ADDENDUM NO. 5

TO: Contract Documents for Construction of Central Avenue Flood Control Improvements - A
FEMA Funded Project - Oracle Project No. 1002549

This Addendum No. 5 changes the bid opening date, modifies the base bid schedule and corrects and clarifies the plans and specifications. Changes to project plans on attached sheets are shown clouded.

CHANNEL SECTION @ CULVERT INLET (CONCRETE APRON)
 STA 9+97.26 TO 10+12.64
 N.T.S.

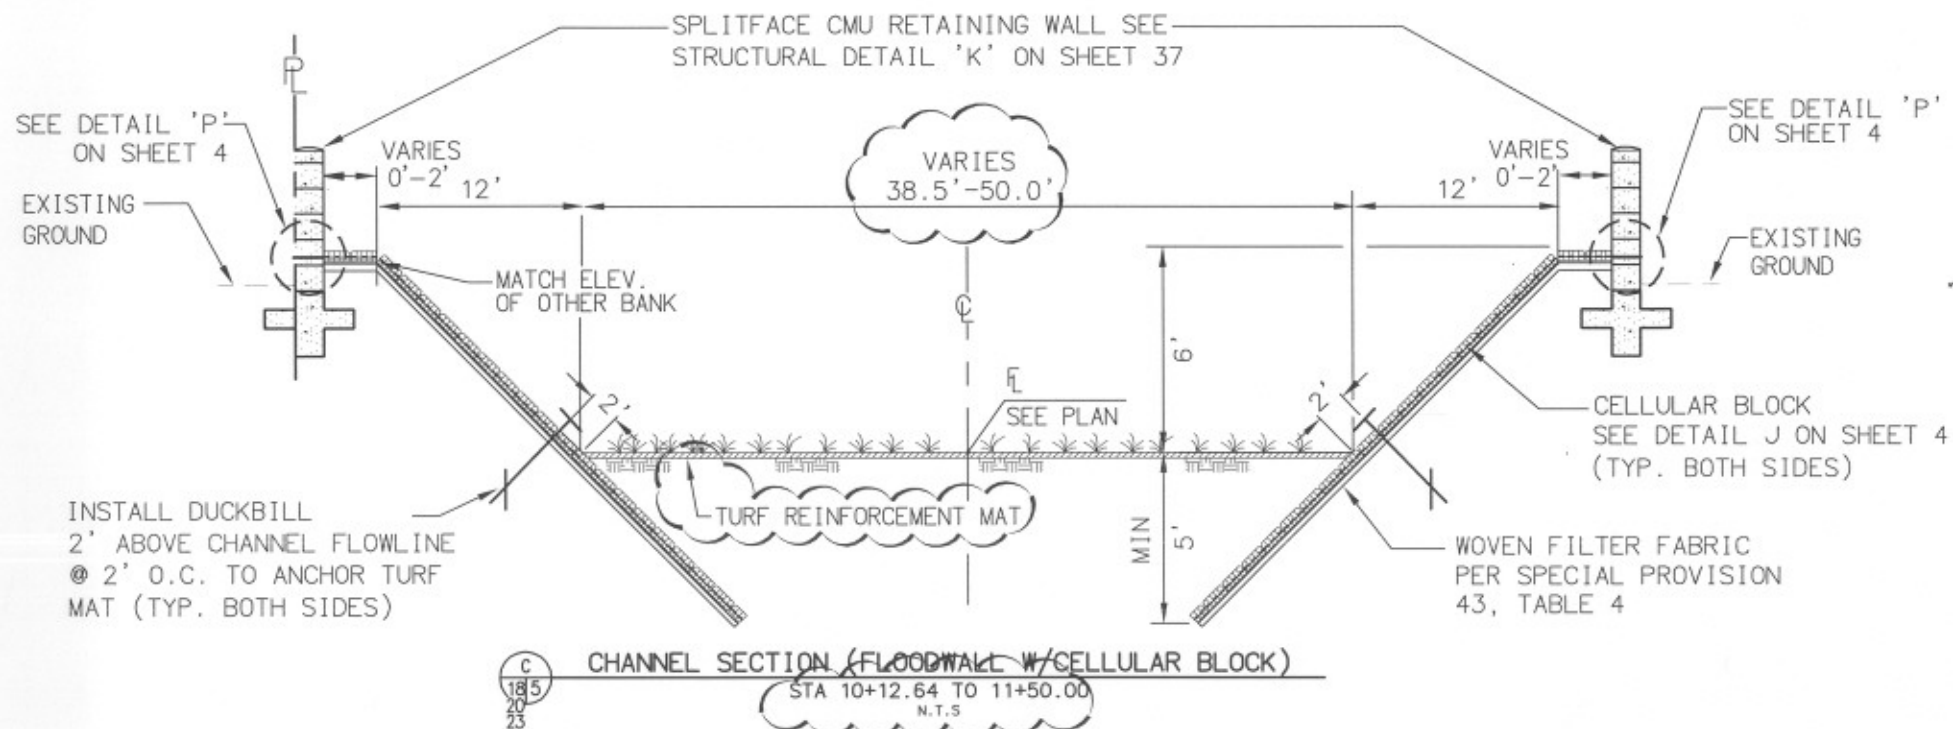
6. On sheet 5 of the project plans, replace Sections B and C with attached Sections B (Addendum No. 5) and C (Addendum No. 5), respectively.

REVISED BOTTOM MATERIAL & WIDTH
 AND BEGINNING STATION FOR CHANNEL
 SECTION ON SHEET 5

REVISED BOTTOM MATERIAL & WIDTH
AND BEGINNING STATION FOR CHANNEL
SECTION ON SHEET 5
